CITY OF SMYRNA

MEMORANDUM

RE: **VARIANCE CASE V24-030**
1900 Sadler Drive – Increase maximum impervious surface area from 49.9% to 50.6%

Figure – 1

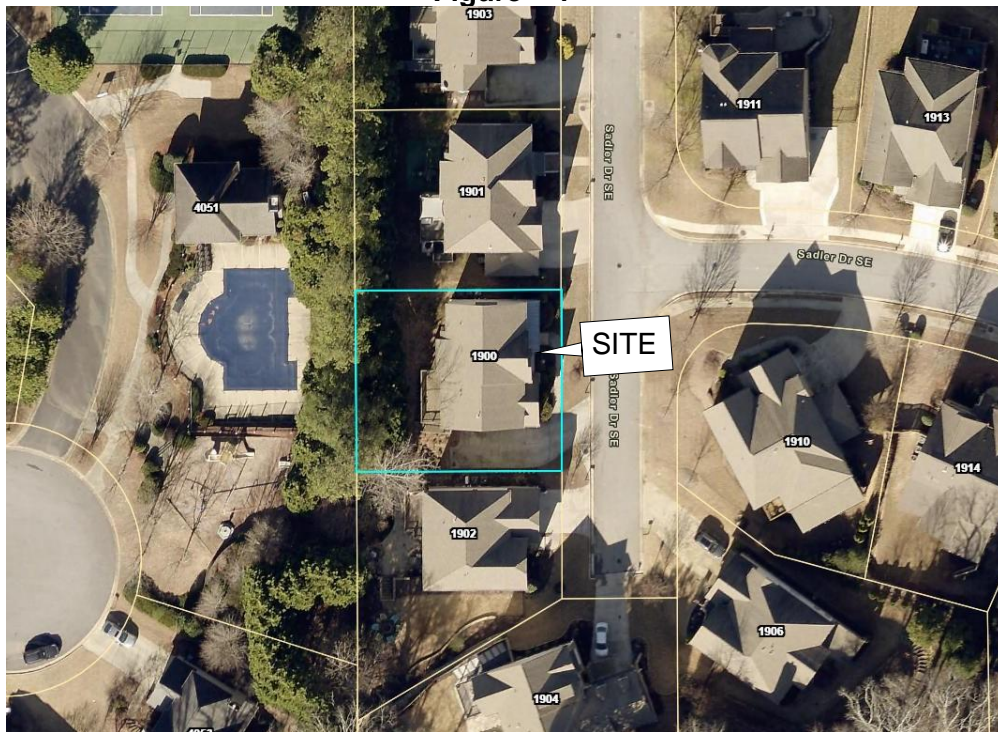
The subject parcel is a 0.16-acre lot located on the west side of Sadler Drive within the Stonecrest Manor subdivision (see Figure 1). The subject parcel and all adjoining parcels are zoned RDA and are all occupied by single-family detached homes, with the exception of the property to the west, which is occupied by the Old Vinings Mill amenity area.
